**AL SHOFA WATER FACILITY
NASSRIYA, IRAQ**

**SIGIR PA-08-124
JULY 23, 2008**

SUBJECT: Report on Construction of the Al Shofa Water Facility, Nassriya, Iraq (Report
Number SIGIR PA-08-124)

Figure 1. Al Shofa Plan (Courtesy of the USACE)

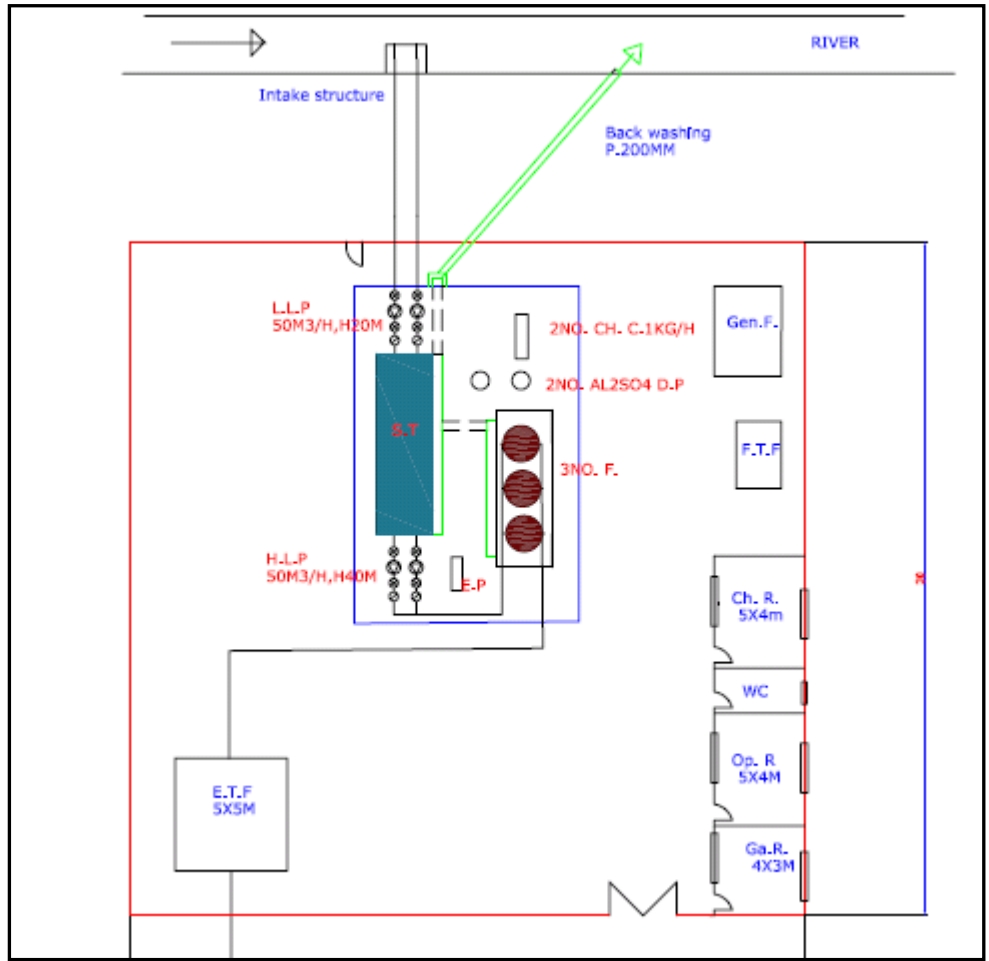
After reviewing all available design drawings and specifications, SIGIR determined the design package was not complete and lacked sufficient details. Specifically, the designs did not provide any system overview detailing the process of raw river water entering the clarifier, being converted to drinking water, and then released to the end point (supply). In addition, the designs lacked necessary details, such as the sizes of pipes used, the potential need for pipe reducers, diameters for air and outlet nozzles for the high pressure filters, equipment lists, and diagram scales.

Further, the design package lacked architectural, civil, electrical, mechanical, and structural drawings for the chemical and operator buildings, and a foundation plan and conceptual layout of the elevated storage reservoir.

Figure 3. Al Shofa design layout (Courtesy of the USACE)

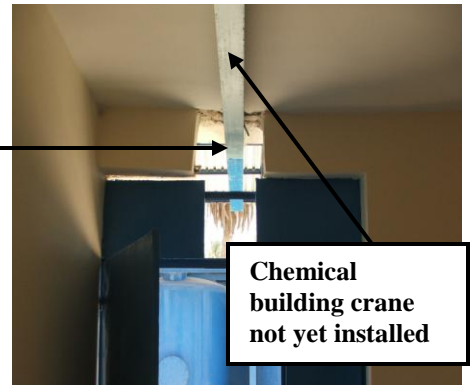
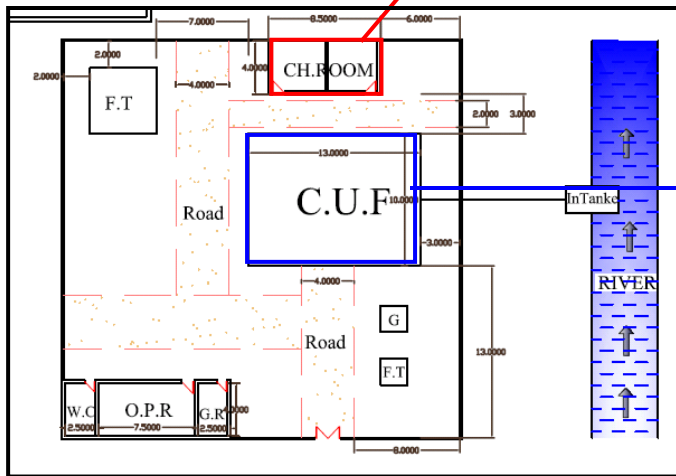
At the time of our second site visit, the contractor had not completed the chemical and operator buildings, water compact unit, light poles, and the sunshade for the water compact unit. For example, electrical work was still required in both the chemical and operator buildings (Site Photo 9). In addition, the contractor had not installed the crane for the chemical building (Site Photo 11). The water compact unit sunshade and individual pieces of equipment still need to be bolted into the concrete slab (Site Photos 12 to 14).
